Subject : Notification and Planning Report to Accompany Section 127 Variation
Application 202.2023.136.3

Application: **Variation to consent to establish and operate a new solar farm, specifically the layout and to resolve an error in the planting plan.**

This report is in respect of an application prepared and lodged, pursuant to Section 127 of the Resource Management Act 1991 (RMA), by Strategy Planning Limited on behalf of the Applicant, Dannevirke Solar Farm Limited, for a variation to consent 202.2023.136.2. the variation seeks to

Figure 1: Original planting and landscaping plan

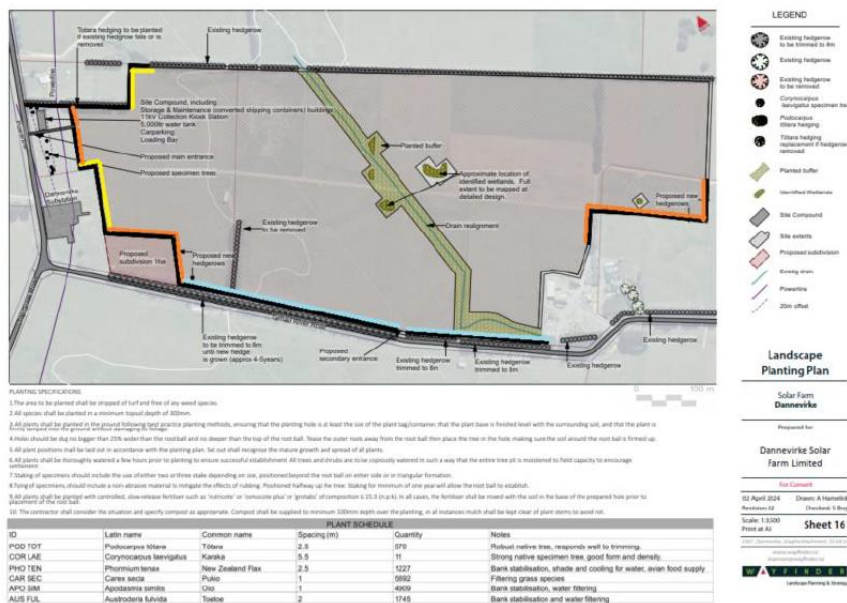
As noted above in April 2024 the applicant applied for a Section 127 application for a variation to this consent seeking an amendment to Condition 12 and subsequent amendments to Condition 1 and Appendix 1 in respect of the proposed planting. This amendment was granted and allows for staging of the planting and replacement of the plan in Appendix 1. Figures 1 and 2 show these plans respectively.

Figure 3: Discrepancy in planting plan – circled in red.

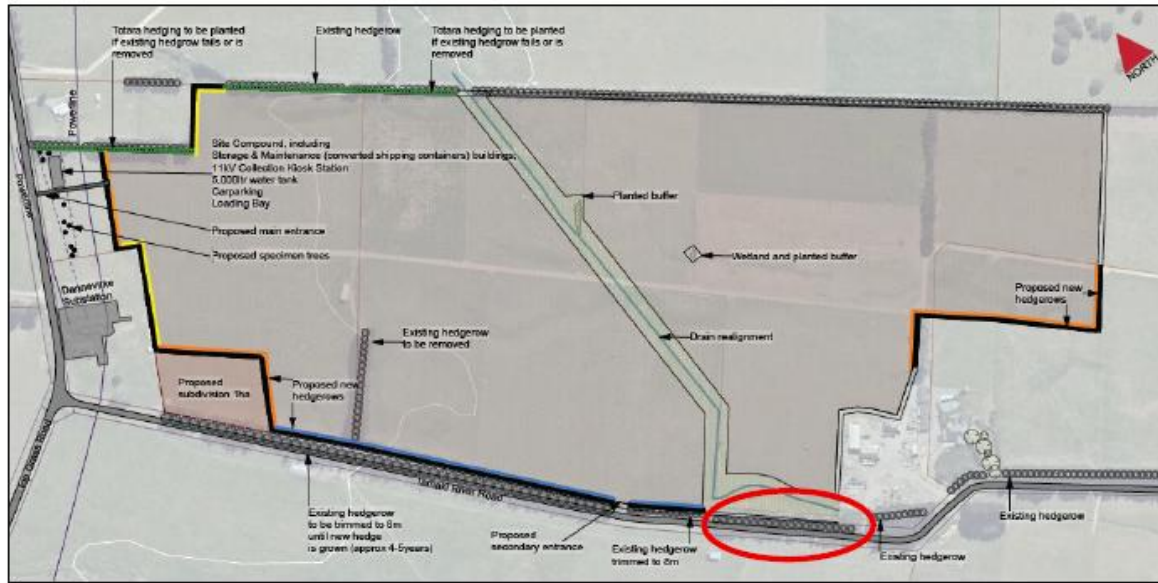
Following granting, it was noted that there was a mistake in the plan in that the extent of planting along the southern boundary was greater than originally allowed for. This discrepancy is shown in figure 3 below.

As noted in section 3, following granting, it was noted that there was a mistake in the plan in that the extent of planting along the southern boundary was greater than originally allowed for. This discrepancy is shown in figure 3.

It is clear from figure 1 that this area was never intended to be planted and it is simply a mistake in the plan at the time of drafting. As such I consider correction of this error is appropriate and no effects are expected to arise.

Figure 4: Updated planting plan sought to be inserted into Appendix 1.

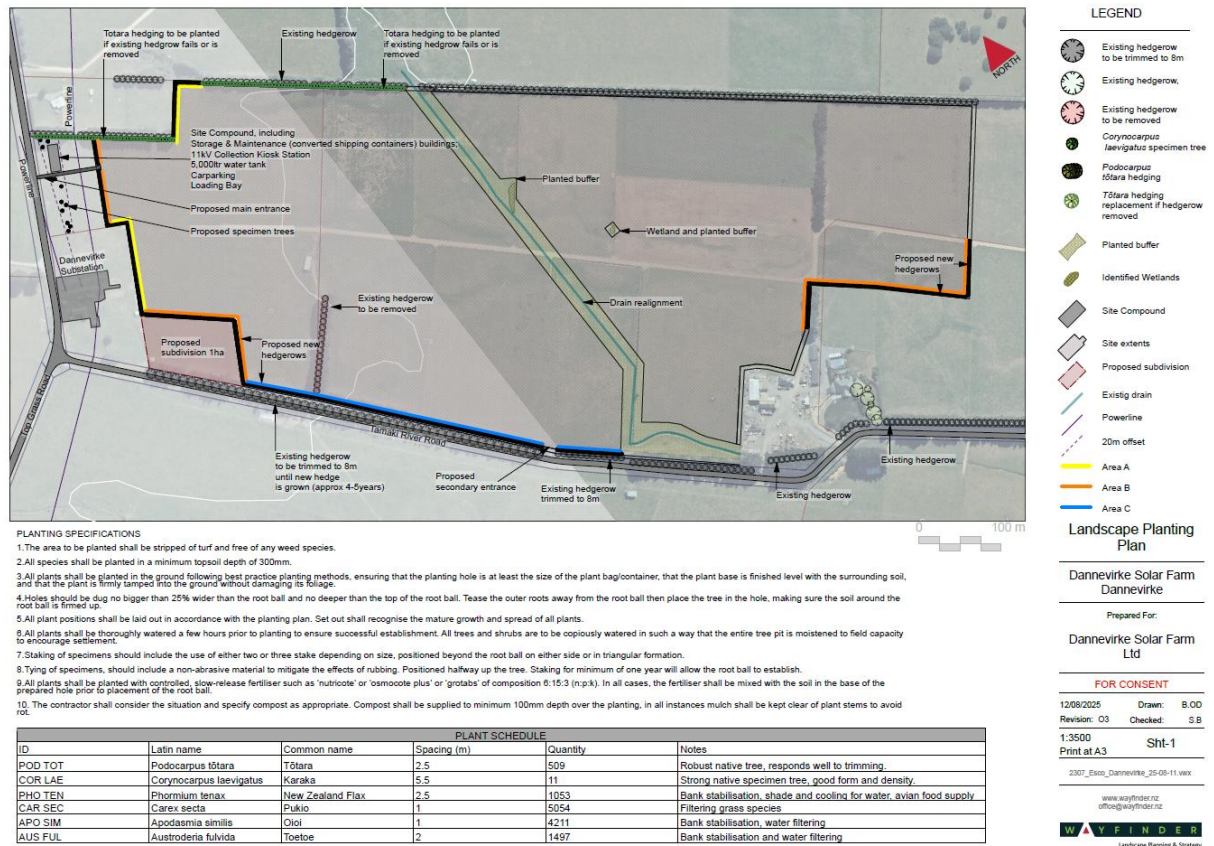
As such the applicant has proffered the plan shown below in figure 4. This plan has been updated to reflect both the correct number and location of the wetlands along with amending the discrepancy in the planting.

- a. ~~Landscape Planting Plan, dated 23 April 2024 drawn by Wayfinder and included as Appendix 1 to this consent document.~~
- b. A response to the further information request received 8 May 2024.
- c. A further update to the application was made on 10 May 2024 confirming iwi involvement in the construction management plan.
- d. The variation applied for under s127 of the Resource Management Act 1991, received by council on 25 March 2025 and held on council file 202.2023.136.2.
- e. The variation applied for under s127 of the Resource management Act 1991, received by council on 12 August 2025 and held on council file 202.2023.136.3. including an updated site plan and landscape plan, drawn by Wayfinder, dated 12/08/2025, Rev 03 and titled "Landscape planting plan Dannevirke Solar Farm, Dannevirke". Attached in Appendix 1.

I have also recommended that it be made clear in the title of Appendix 1 that the plan has been updated per variation 202.2023.136.3.

Attachment 1: Updated Landscape Planting Plan

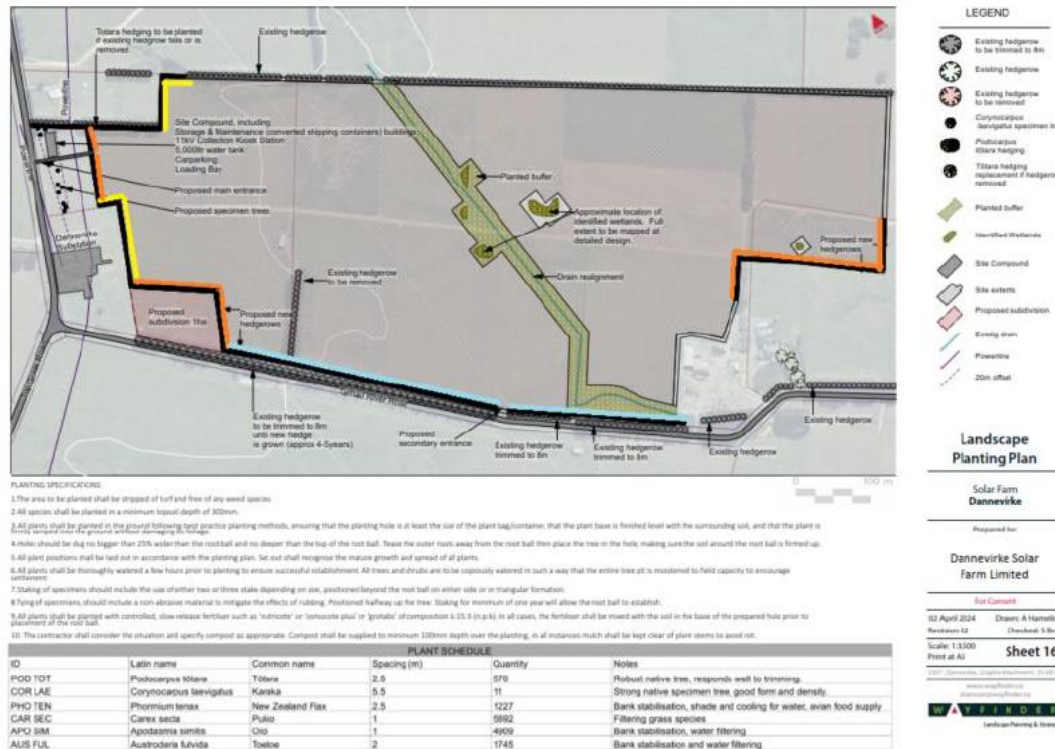
The applicant has applied for a Section 127 application for a variation to the consent seeking an amendment to condition 12 and subsequent amendments to condition 1 and appendix 1. They are seeking that the aforementioned planting be staged. The applicant has requested that condition 12 be altered as follows:

- Planting the boundary of the site with totara hedging with a spacing of 2.5m.
- Area A (yellow) – landscape planting to be established by 31 May 2025.
- Area B (orange) – landscape planting to be established prior to construction completion, in spring 2025.
- Area C (blue) – landscape planting to be established prior to construction completion, in spring 2025.

And replace appendix 1 with the following plan:

As discussed above this also request necessitates an amendment to Condition 1 to reflect the amendments.
